Arlington Conservation Commission

Date: Thursday, May 7, 2020

Agenda

Construction & Erosion Control Details

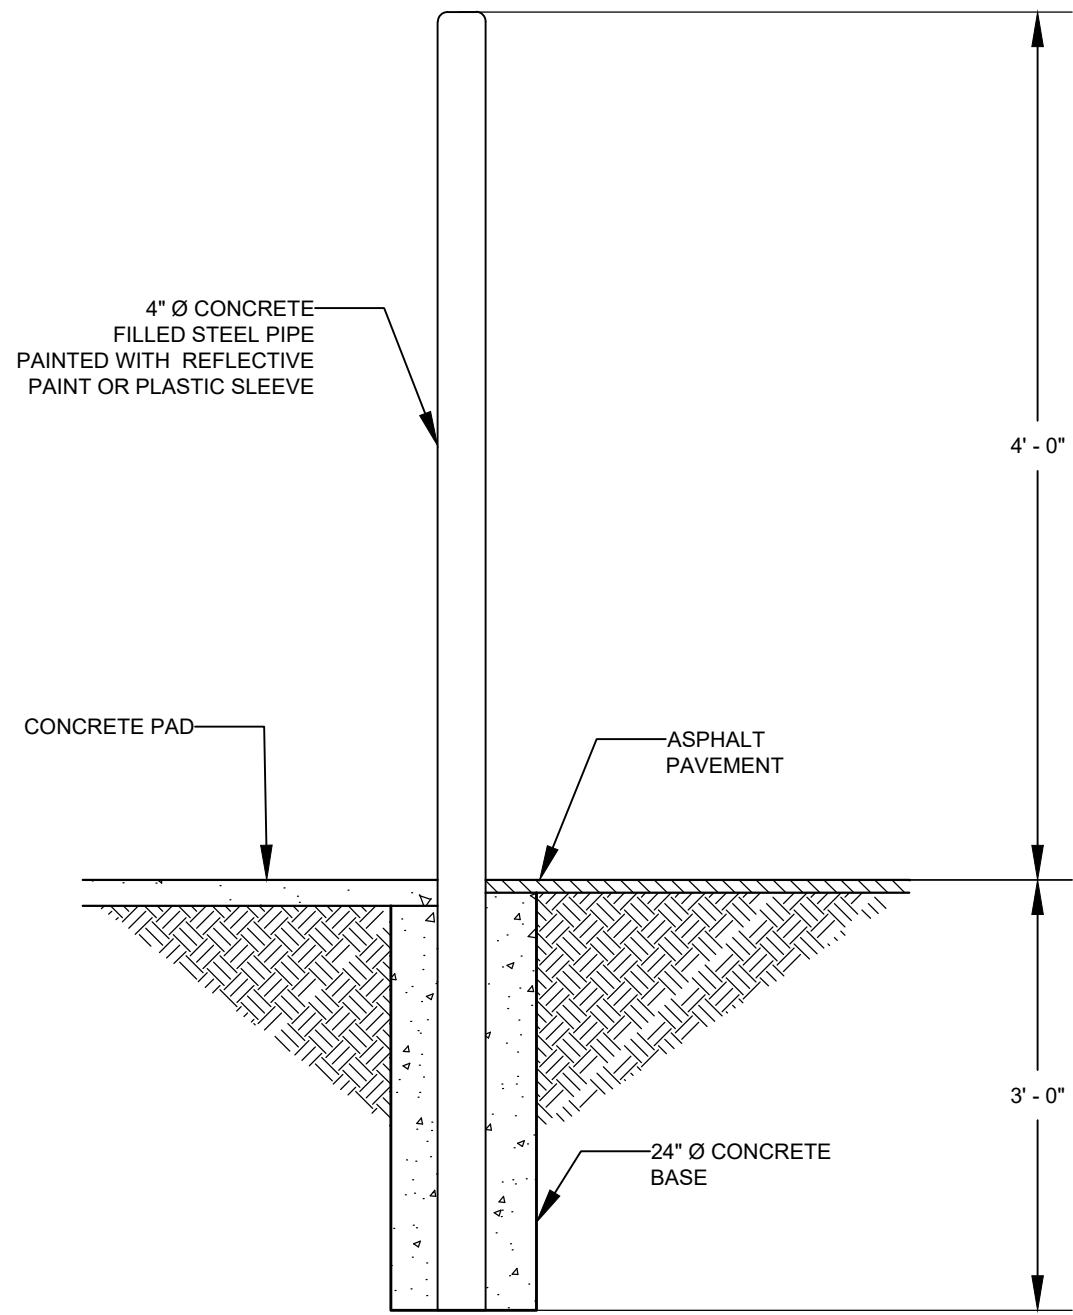
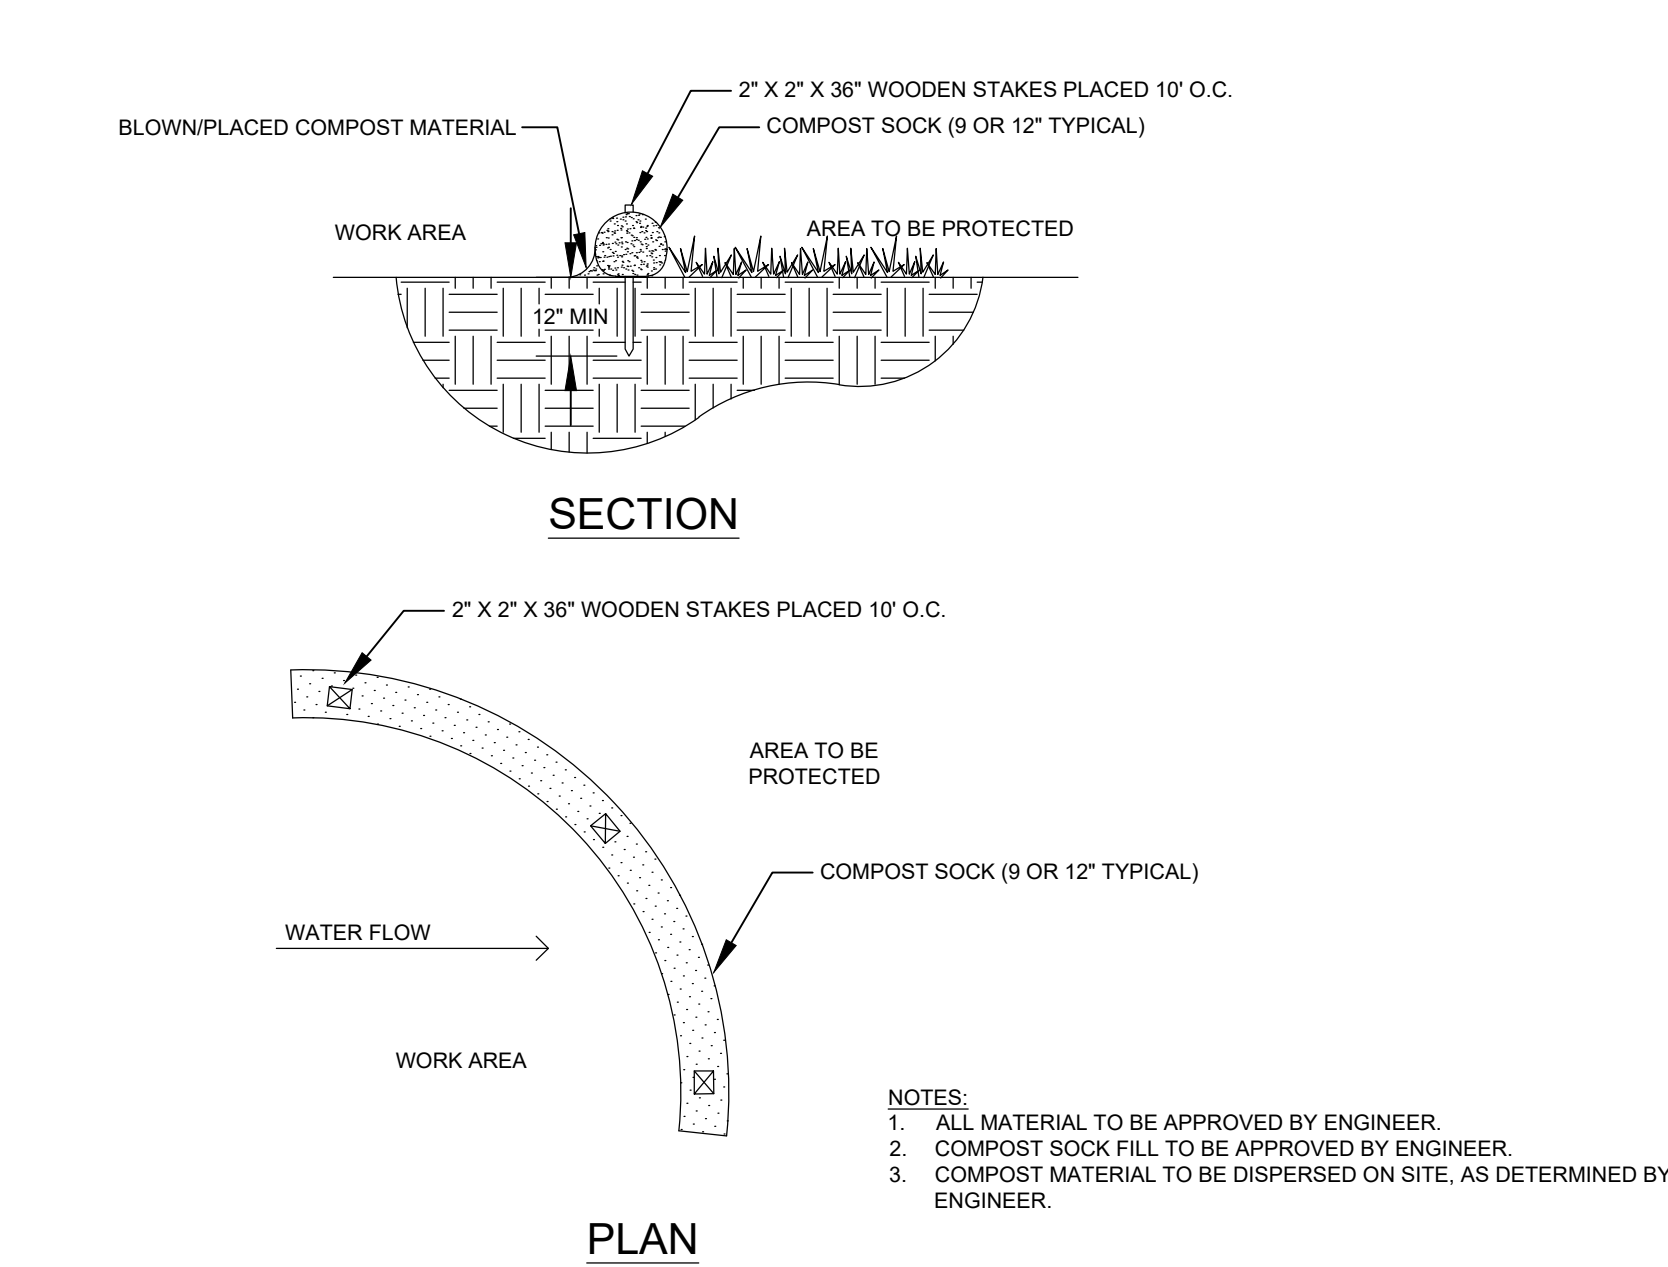
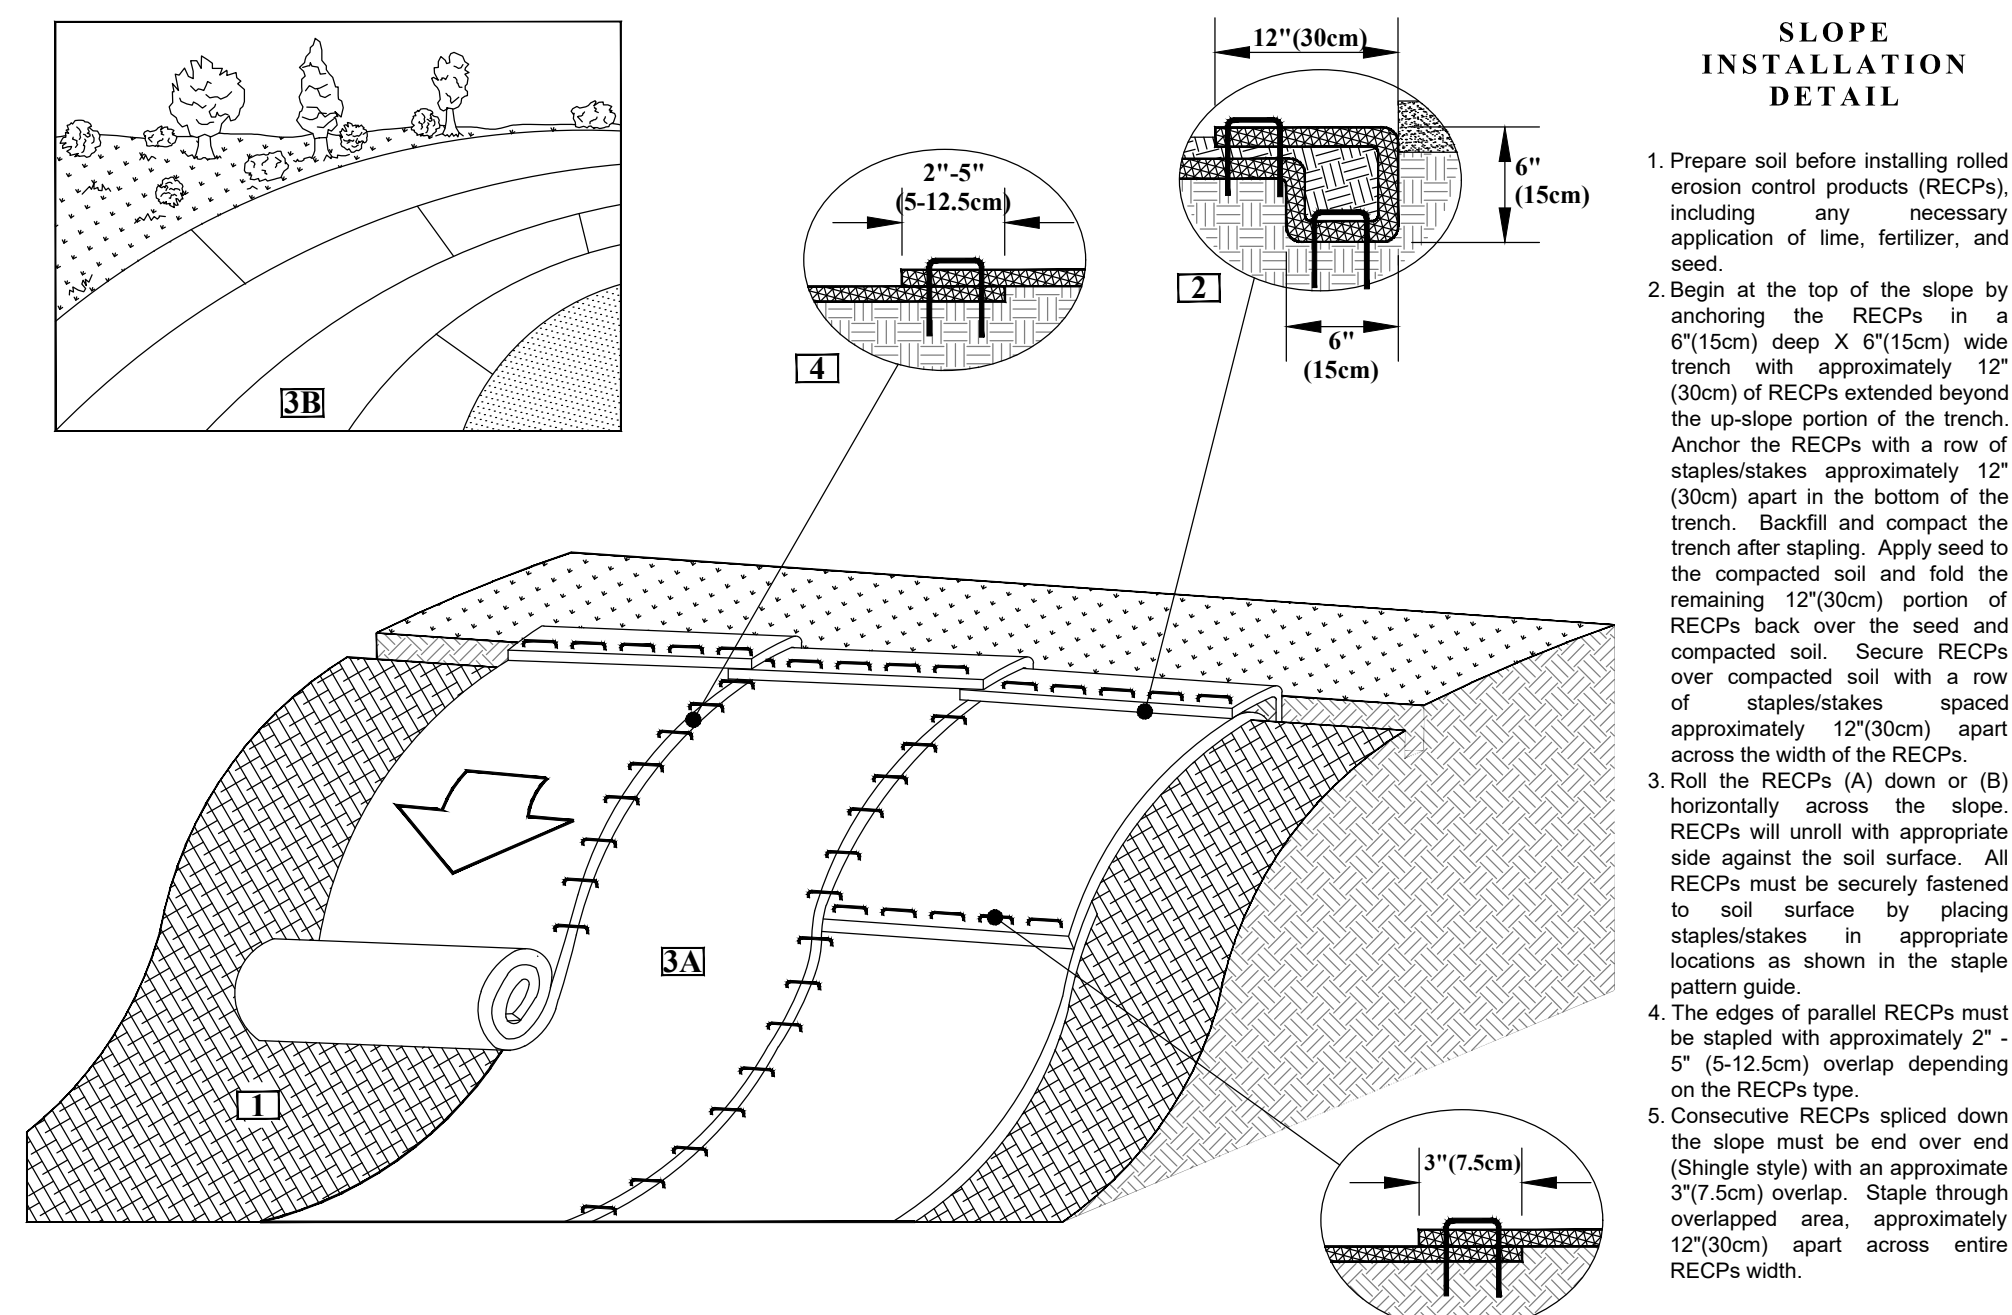
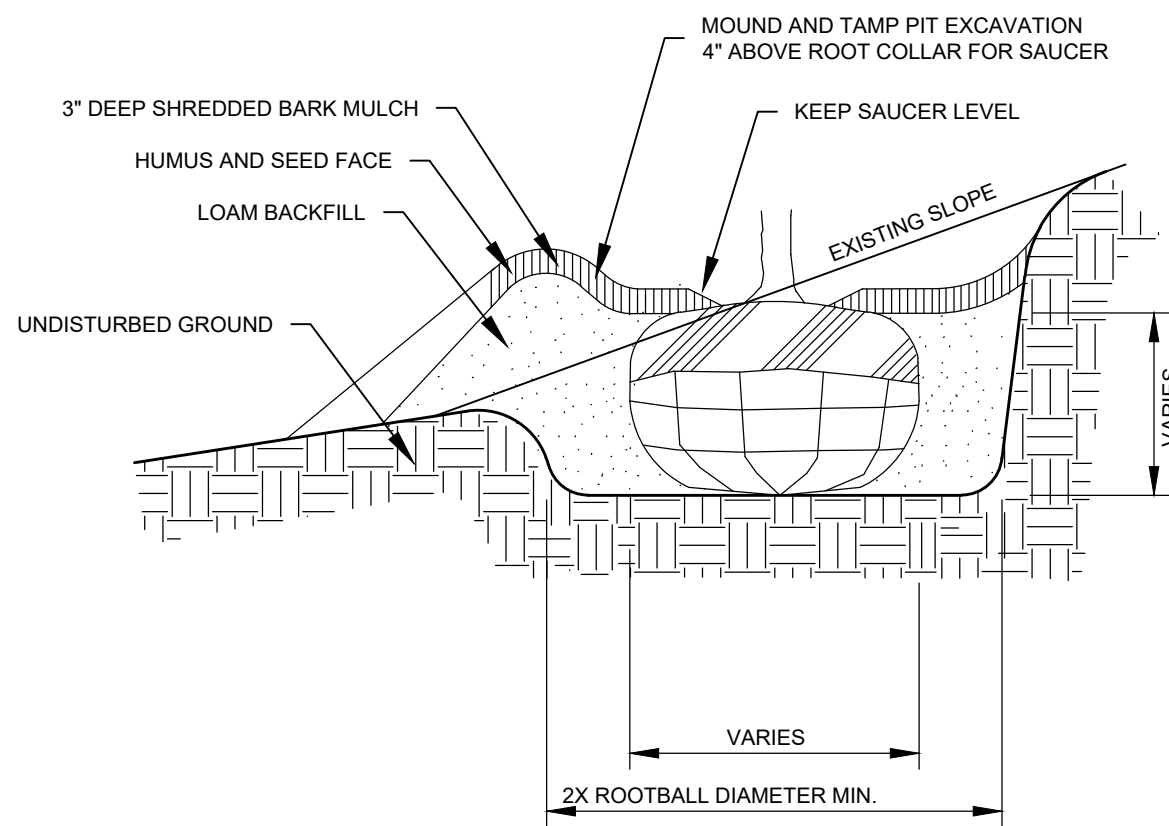
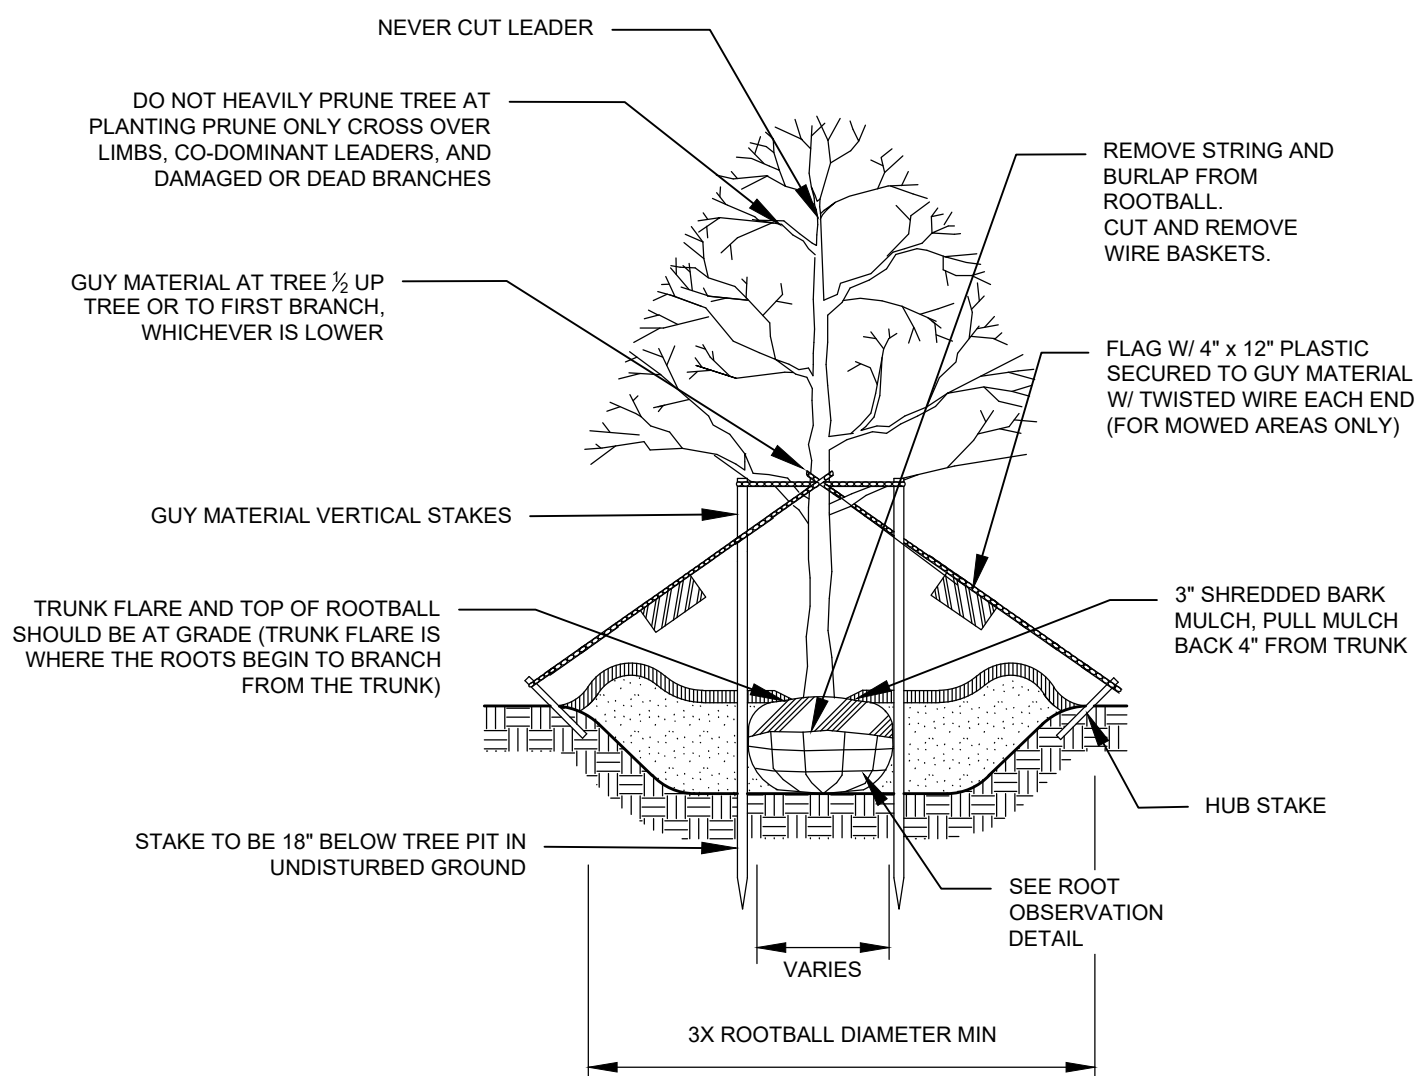
C. Tirone asked whether the grease waste container will be replaced and if additional precautions will be taken to prevent leaks in the future. C. Tirone requested an Operation and Maintenance plan for the grease waste container.

- 1) an O&M plan for the grease waste container
- 2) shrubs/plugs in addition to the grass mix proposed
- 3) amended plans with a 12" compost sock as erosion control

1. A weekly inspection record form for the subject property has been provided. See attached.
2. In addition to the erosion control matting and grass mix, Sweet Ferns (*Comptonia Peregrina*) are proposed to be planted throughout the proposed excavation area as specified on sheets C1.1 and C5.1. See the attached CZM list for details on Sweet Ferns.
3. Proposed perimeter erosion and sediment controls during construction shall be 12-inch compost socks. See sheets C1.1 and C5.1.

Attachments: Revised Site Plan Sheets
- C1.1 Site Plan
- C5.1 Construction & Erosion Control Details
Weekly Inspection Record Form
CZM Native Shrubs and Groundcovers List
